CITY OF ROCKVILLE HISTORIC DISTRICT COMMISSION STAFF REPORT

March 20, 2003 MEETING NO. 03-03

APPLICATION: HDC03-0234

APPLICANT/ James Vitol **OWNER:** 11 Wall Street

11 Wall Street

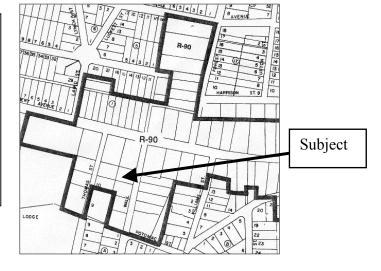
The pad and air conditioner unit are proposed to be located on the north side of the house, potentially visible from the right-of-way. From an aesthetic standpoint, it would be preferable if the unit could be placed to the rear (west) side of the house to be less obtrusive. However, it would occupy valuable privacy space and pose more of a noise nuisance in the rear. Therefore, if the unit is located on the north side of the house, as proposed, it should be screened with appropriate and attractive landscaping, especially since the magnolia tree in this vicinity is to be removed as part of the application.

Although both trees proposed for removal in this application are alive and pose no immediate hazard, the City Forester agrees with the owner that they should be removed. The magnolia is not a good specimen and has been poorly pruned. It was planted too close to the house (within four feet) and consequently is leaning away in search of light. It is located in the immediate vicinity of the proposed air conditioner unit and pad. As it continues to grow, it will create more problems and a potential threat to the house. The magnolia should be replaced with dense screening if this location is approved by the HDC for the air conditioner unit

- 1. A rear location for the air conditioner unit and pad is considered preferable to the more visible side location. However, staff understands that the side location would be preferable to the owners as it does not detract from use of the private rear yard. A side location requires adequate screening to minimize its visual impact.
- 2. The dogwood should be replaced with a similar ornamental tree and the magnolia should be replaced with appropriate screening material in the vicinity of the air conditioner unit/pad.
